CONSERVATION MANAGEMENT PLAN

LOCOMOTIVE “BLACKIE”

COMMENTS ON PRASA DISPLAY PROPOSAL

CAPE TOWN STATION

**COMMENTS ON DISPLAY ENCLOSURE
IN FORECOURT OF CAPE TOWN STATION
AS PROPOSED BY PRASA**

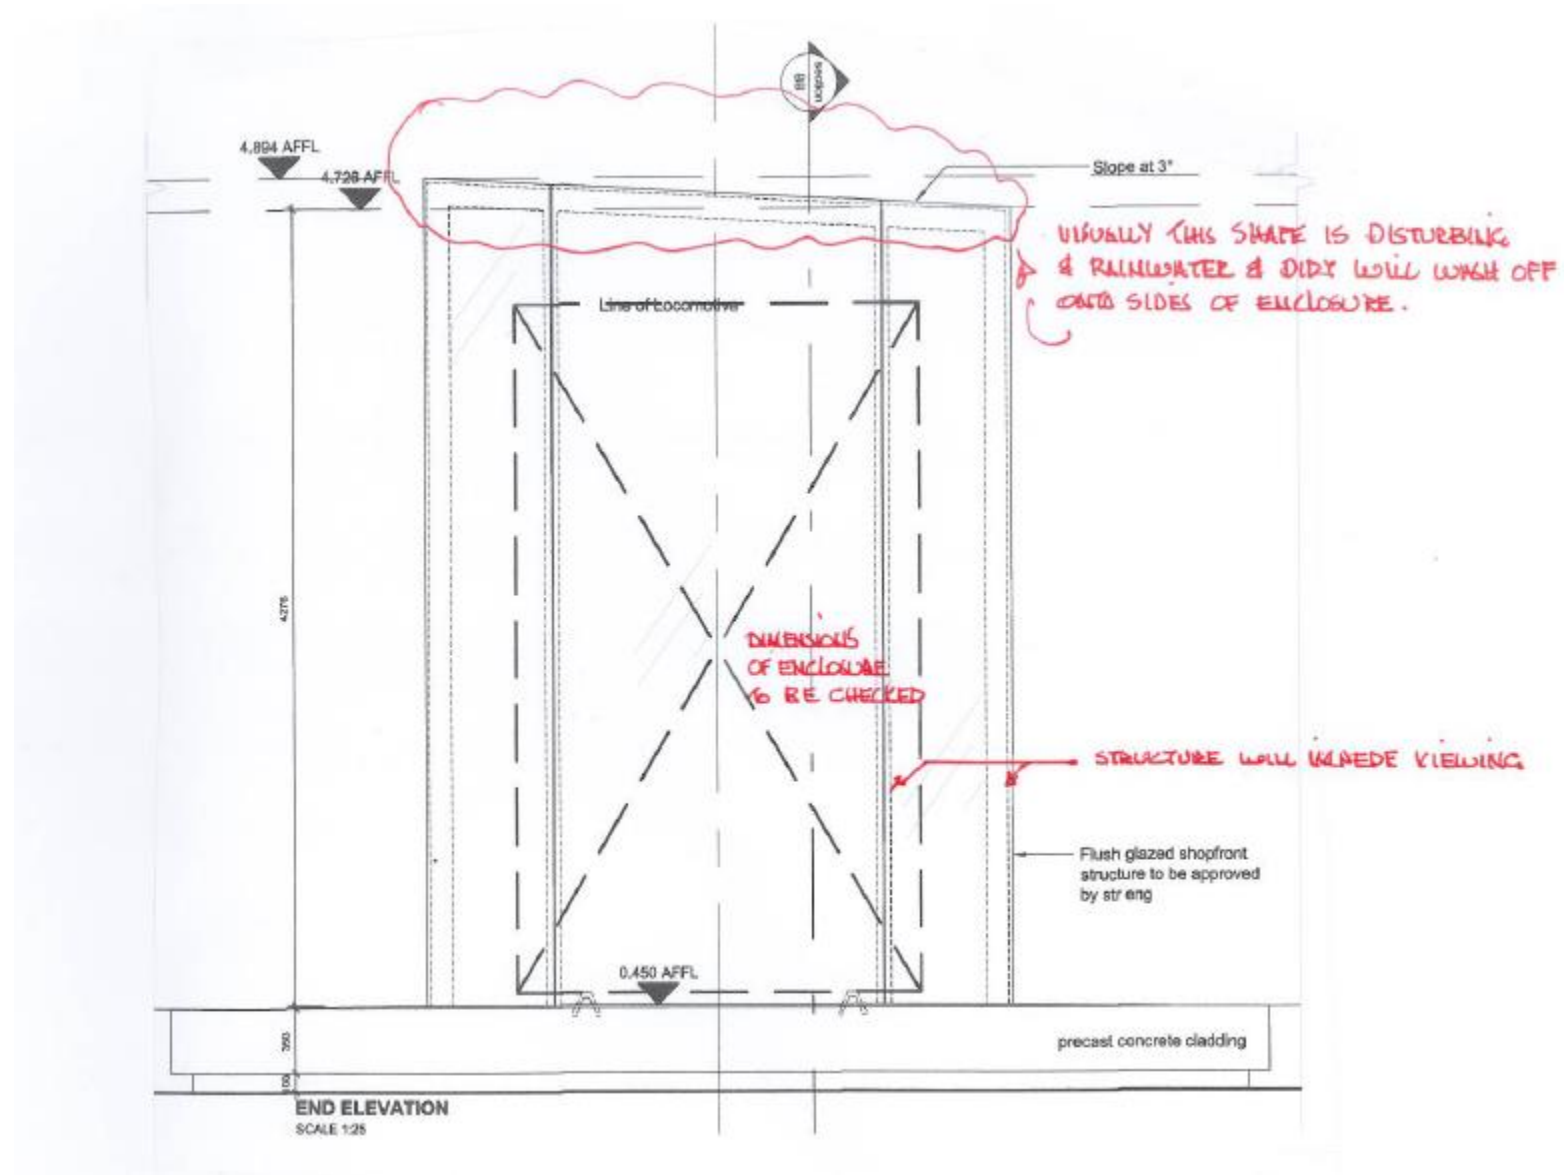
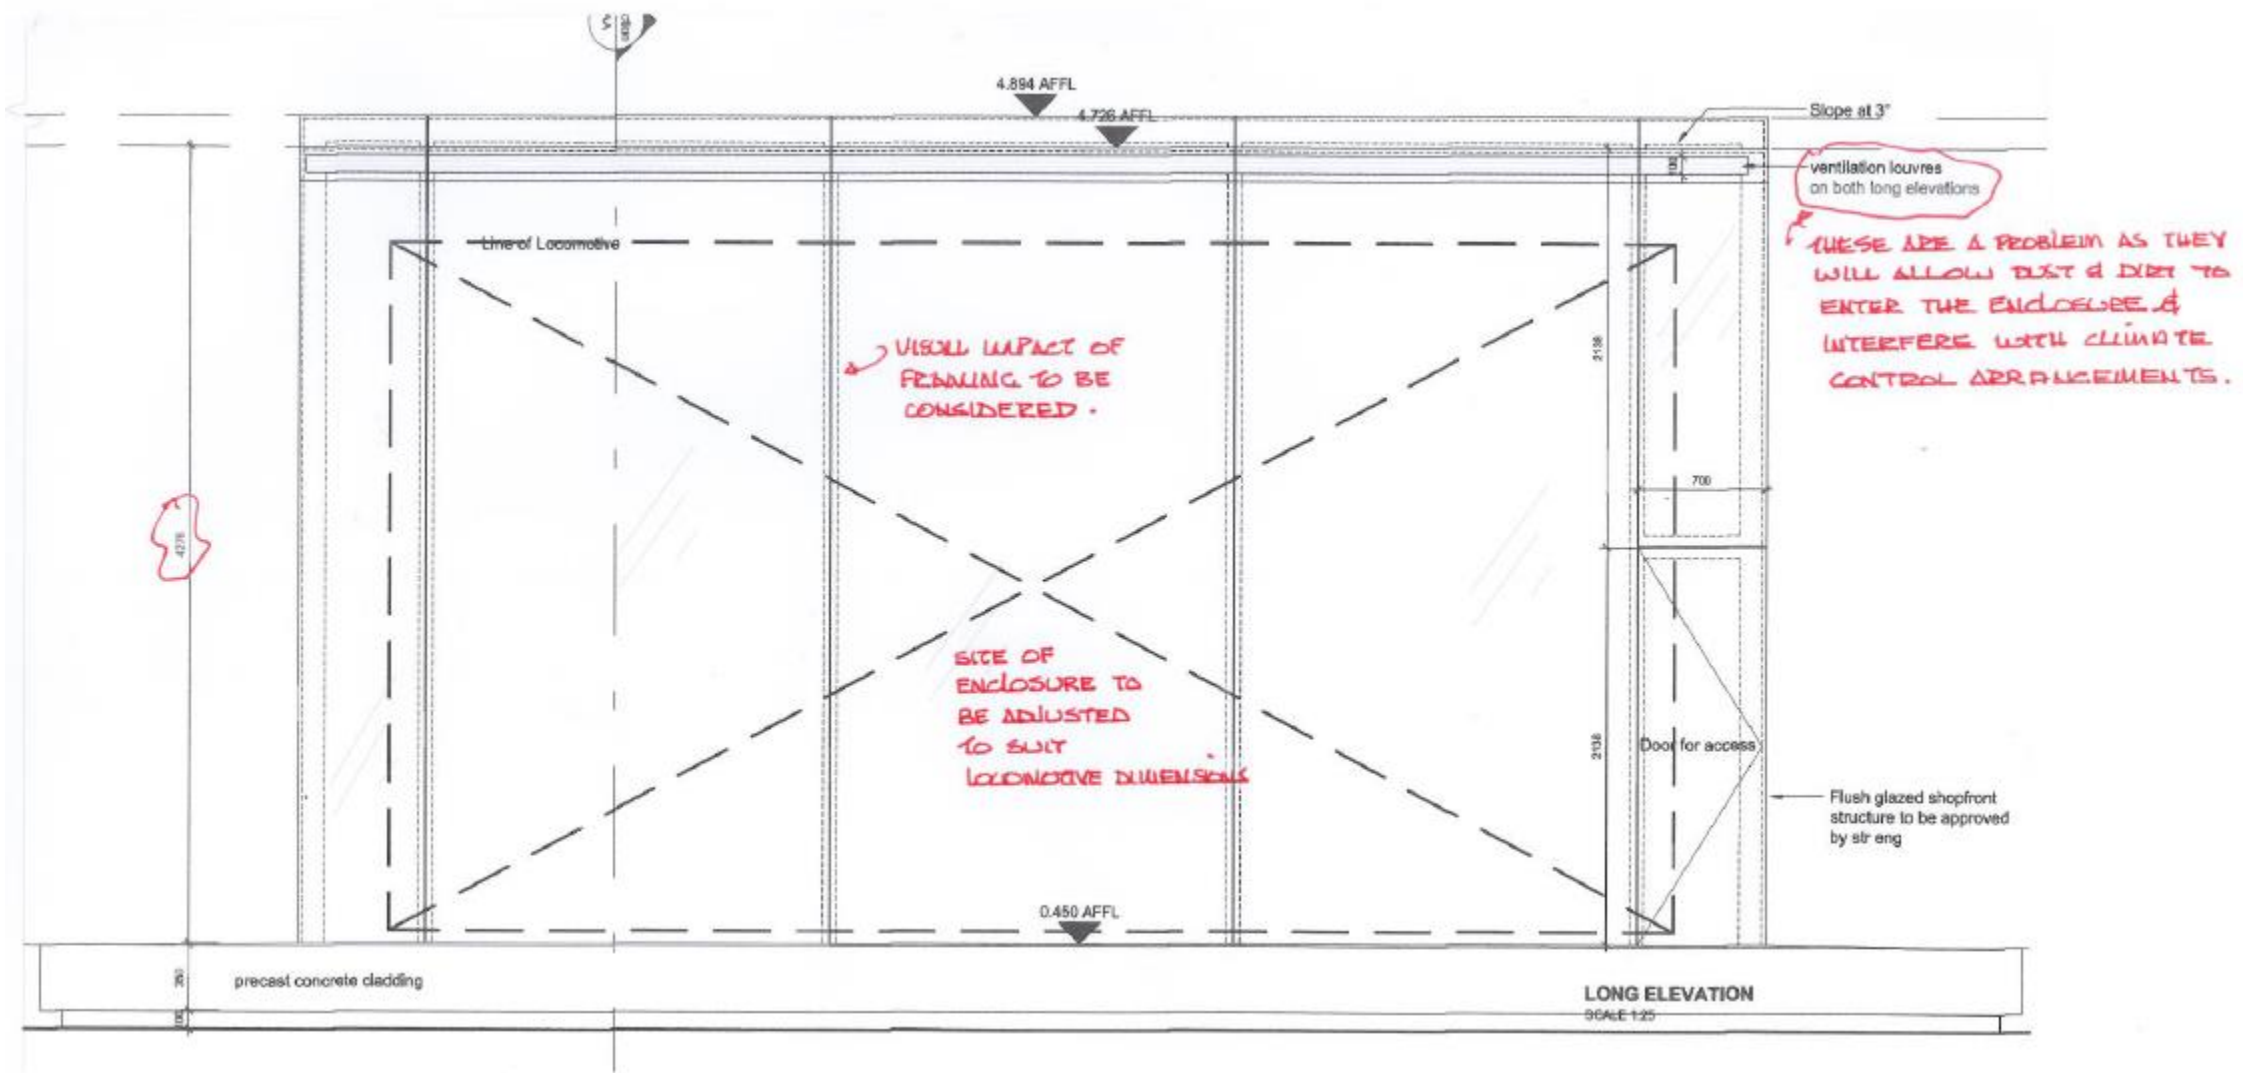
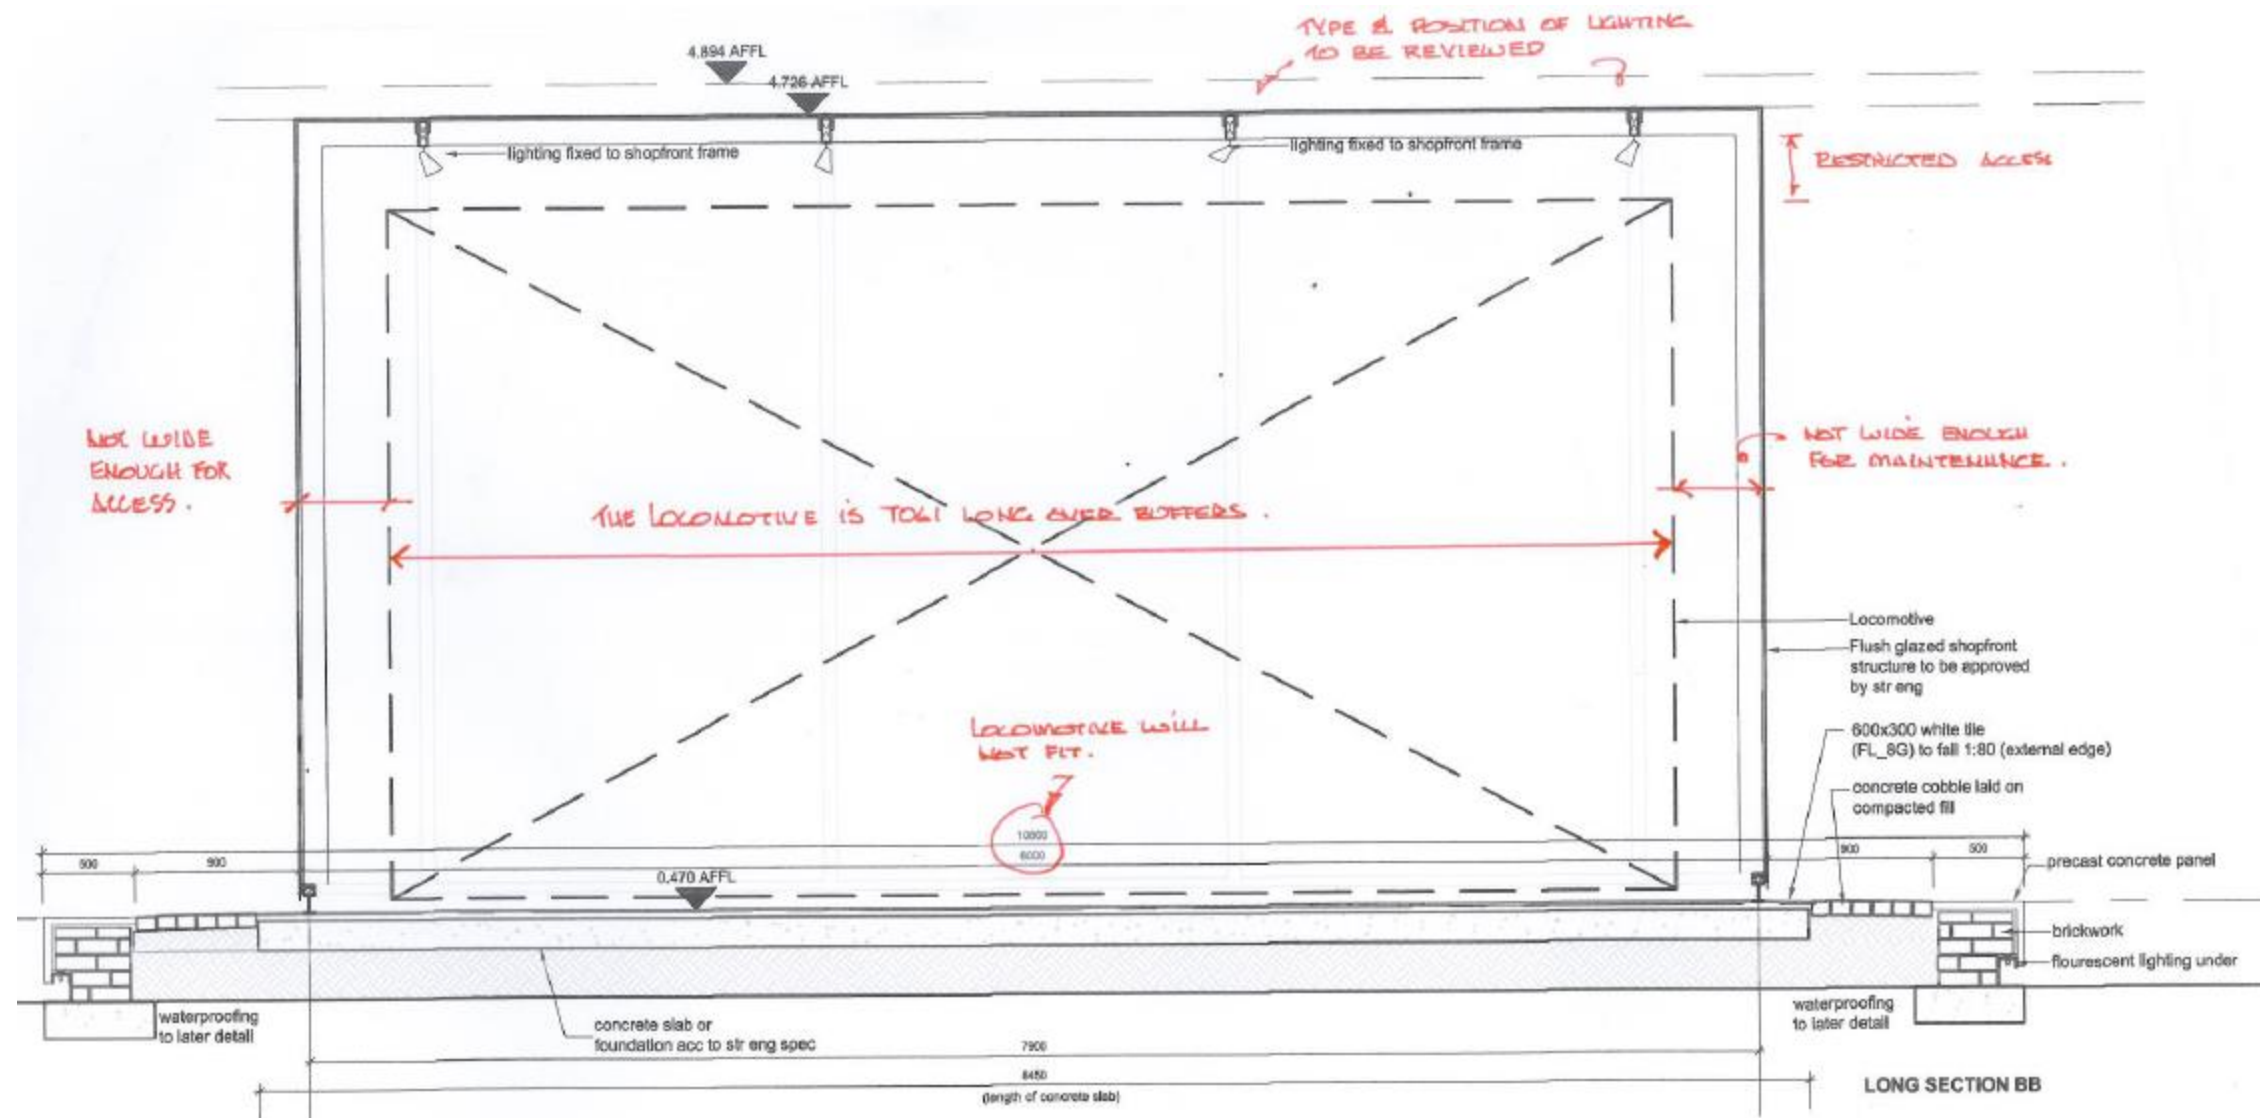
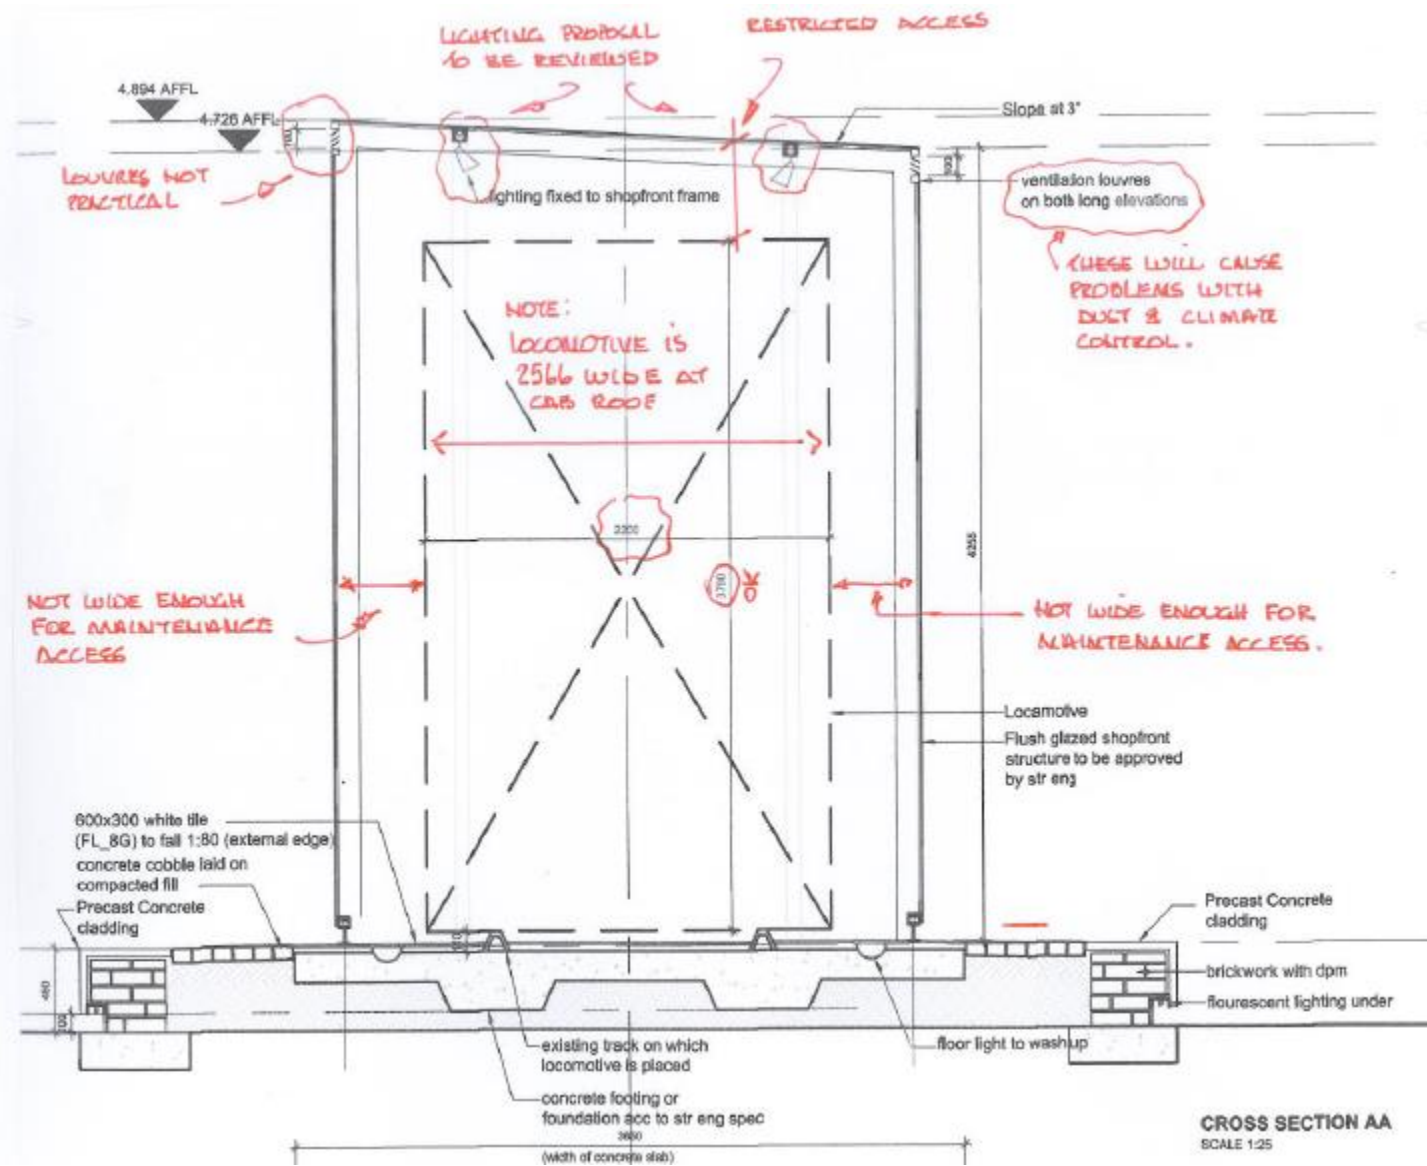
1.2.1. The design of the roof of the glass display enclosure will result in dirt accumulating on top of the enclosure and washing down the sides of the enclosure which will impede viewing and become a maintenance problem.

1.2.2.1. The proposal submitted by PRASA does not address the issue of protecting the locomotive from the effects of sunlight.

1.2.2.2. The locomotive will be exposed to extreme temperature fluctuations and this will result in corrosive climatic conditions within the enclosure.

1.2.3.2. The provision of ventilation louvres at high level along the sides of the enclosure will interfere with the climate control and will allow dirt and dust to enter the enclosure.

1.2.4.1. The PRASA proposal does not provide sufficient space within the enclosure around the locomotive for maintenance staff to move about and clean both the inside of the enclosure as well as the locomotive without damaging the locomotive.

1.2.4.2. The PRASA proposal does not provide sufficient space above the locomotive between the cab roof and the underside of the display enclosure roof to allow for proper access for cleaning and maintenance to the lighting system.

1.2.5.3. Limited structural information of how the enclosure is to be constructed.

1.2.6.1. The limited information of the lighting system that is shown on the PRASA drawings do not have any details of the specifications for the lighting.

1.2.6.2. From inspection of the drawings the lighting system that is shown is not suitable.

1.2.8.2. The design of the roof of the glass display enclosure will result in dirt accumulating on top of the enclosure and washing down the sides of the enclosure which will impede viewing and become a maintenance problem.

1.2.2.3. Should PRASA still want to display the locomotive in the station forecourt then a proper structure will need to be erected that will provide shade and control exposure to direct sunlight whilst not obstructing the view of the locomotive.
